ANC 3C Resolution No. 2015-021
Regarding DDOT Public Space Application to Install a Fence for the
Vatican Embassy, located at 3339 Massachusetts Avenue, NW

SUBJECT: FMBZA 19013 –Application of the Apostolic Nuncio of the Holy See, pursuant to 11DCMR § 1002 and §206 of the Foreign Missions Act

SUBJECT: FMBZA Case No. 19013 – Vatican Embassy

Attachment II – Potential Alternative Fence Location

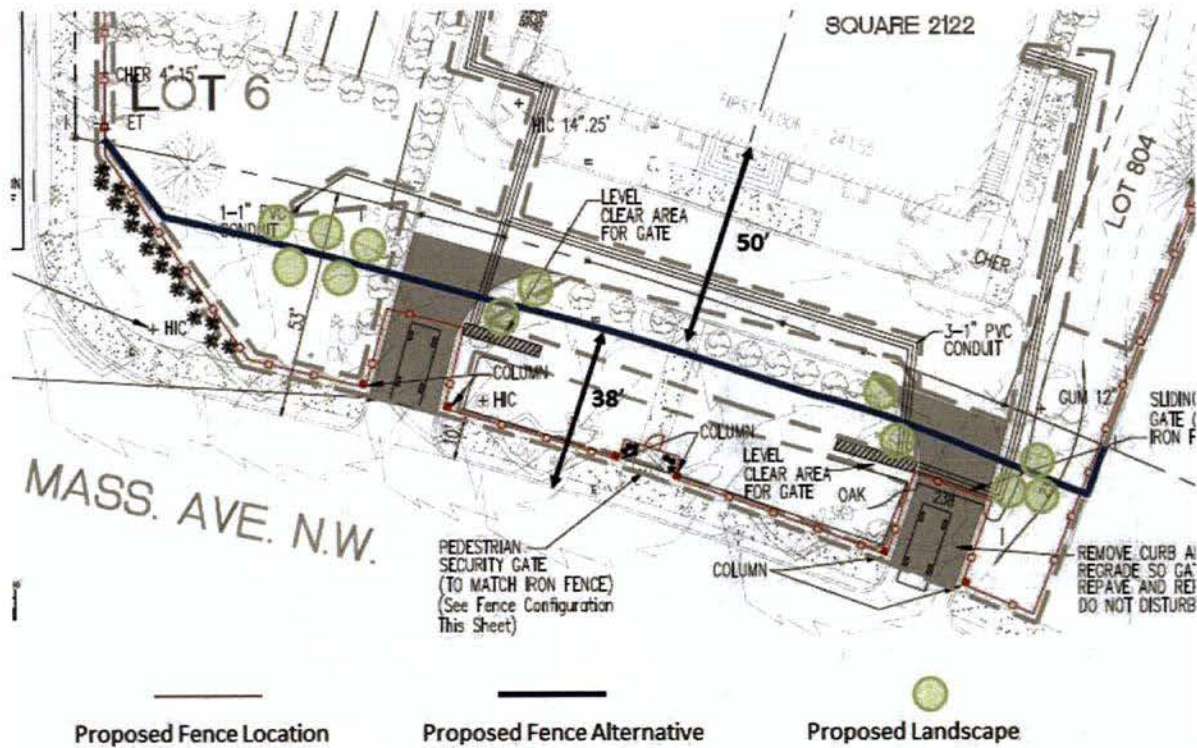
The proposed security buffer (the distance between the proposed fence and the building) along Massachusetts Avenue also exceeds the 50-foot security setback for Level IV facilities, recommended by the U.S. Department of Homeland Security's Interagency Security Committee (ISC) and adopted in August 2013.⁴ Foreign embassies and consulates in the United States are identified as Level IV facilities. The embassy main building is 35 feet from the property line and more than 80 feet from the curb, leaving a generous amount of set back from the building to where a security fence providing the security buffer could be located. A security fence pulled back closer to the property line, as far as 38 feet from the curb, would maintain the 50 distance from the embassy and be more consistent with the intent of public space regulations - see alternative fence location, Attachment III, developed by OP Staff. Historic Preservation Review staff indicated that they do not object to the alternative location. OP contacted the representative of the applicant to request a meeting to discuss the alternative, but the request was declined.

The Office of Planning, therefore, has no concerns with the proposed design, materials, or height of the proposed security fence and gates, but concludes that it would be made more consistent with District interests in maintaining the open character along Massachusetts Avenue and maintaining the health of street trees by placing the fence up to 38 feet back from the curb. This would also satisfy U.S. Department of Homeland Security criteria and embassy needs for the standard 50 foot security buffer between the fence and the building.

Figure 1. Fence Installation Plan (Source: Embassy)

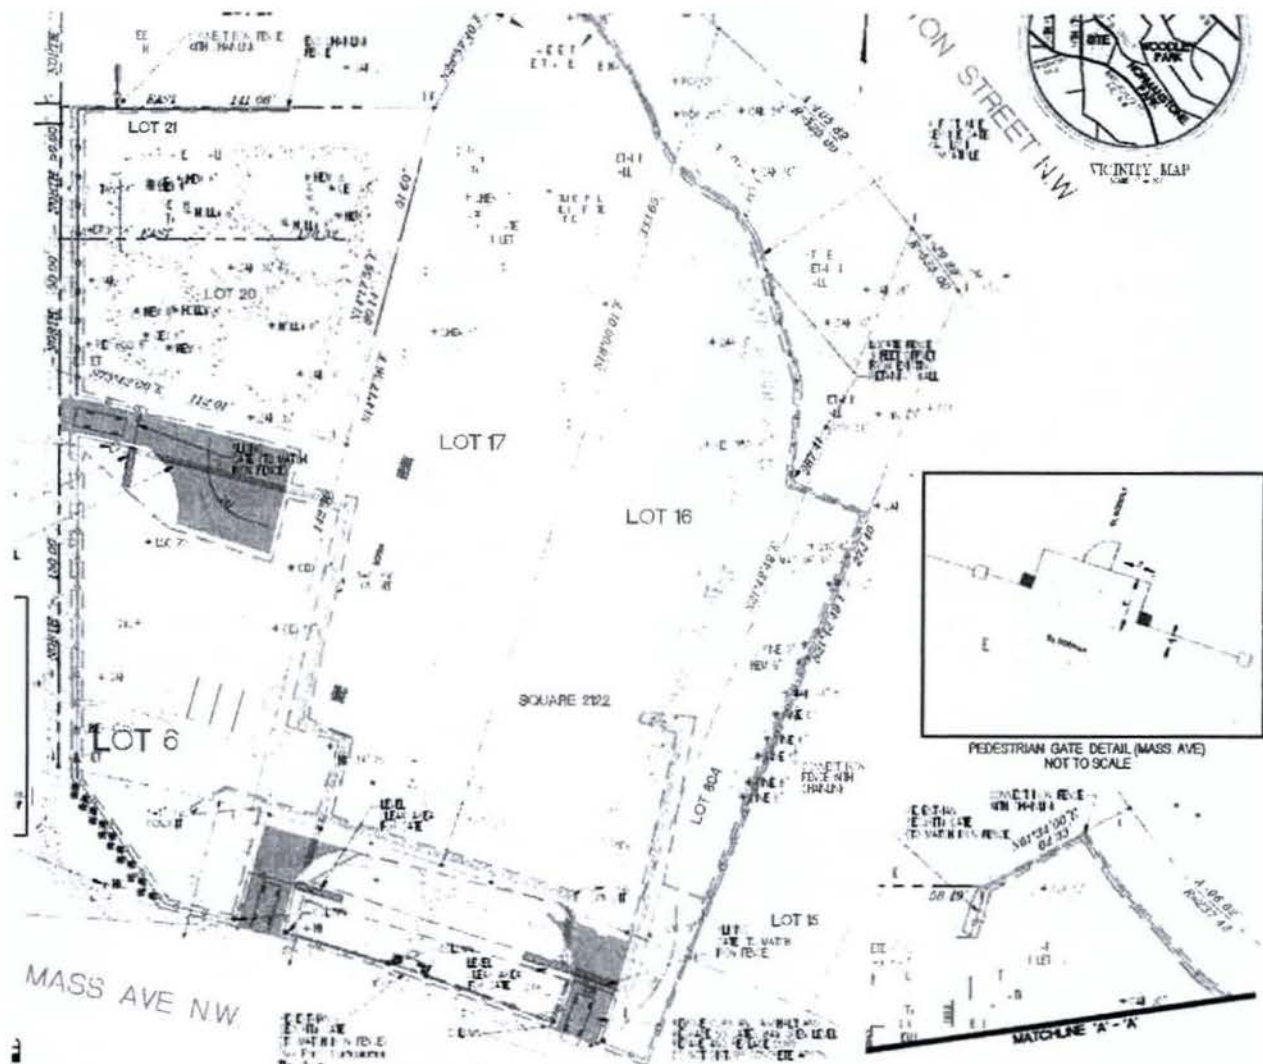
The fence is proposed to be set back from the Massachusetts Avenue sidewalk edge by 18 inches. This will place it within the public parking area of Massachusetts Avenue. On the 34th Street side the fence is approximately five feet behind the sidewalk, encroaching into the BRL area. There are three recessions in the Massachusetts Avenue side fence line, two for the driveways and one at the lead walk, to allow cars or pedestrians to clear the sidewalk area while waiting to enter.

DDOT would be amenable to working with the Embassy to place a fence that meets their security needs, even if this were located in portions of public space. However, the currently proposed location does not seem to represent a location that seeks to compromise between the public space impacts and the security concerns. The U.S. Department of Homeland Security's Interagency Security Committee (ISC) recommends a 50-foot security setback for facilities such as the Embassy, which DDOT would suggest as a starting point for this proposal. This would allow the fence to be setback approximately 38 feet from the curb, significantly further back within the public parking zone, and further from the trees.

Consideration for the large existing trees has been made, which the Embassy, the local ANC, and the District desire to maintain. The Embassy states that the fence as located minimizes the potential impact on the existing trees as they draw more of their nutrients from the non-street side. DDOT conducted a site review with the ward arborist, and disagrees that the proposed fence location is optimal for the trees. A fence outside the trees' root zones, for instance at the property line, but at minimum, located as far from the trees' trunks as possible is preferable.

While great concern for the trees has been highlighted, and it seems was necessary to receive ANC support for this project, DDOT is concerned about the tree health based on the currently proposed fence location. Further, there are some public space trees that appear to be missing from the plan, which could also be impacted. Finally, there are tree impacts along almost the entire fence line, though some of this is on private property.

- DDOT recommends that the fence be located approximately 38 feet behind the curb, leaving 50 feet between the fence and the Embassy building, and preserving a greater portion of the public space as publicly accessible, allowing for better chance of tree preservation, while still meeting the Embassy's security needs
- If this cannot be agreed to, DDOT suggests the FMBZA continue this case to allow further dialogue, which could lead to a fence location that would be more appropriate for this prominent corner location. At a minimum, the DDOT Urban Forestry Administration's guidance below should be included in any conditional approval for this project.
- To further that subsequent discussion, if necessary, DDOT requests additional information from the Embassy to more specifically understand the range of allowable fence locations for security purposes
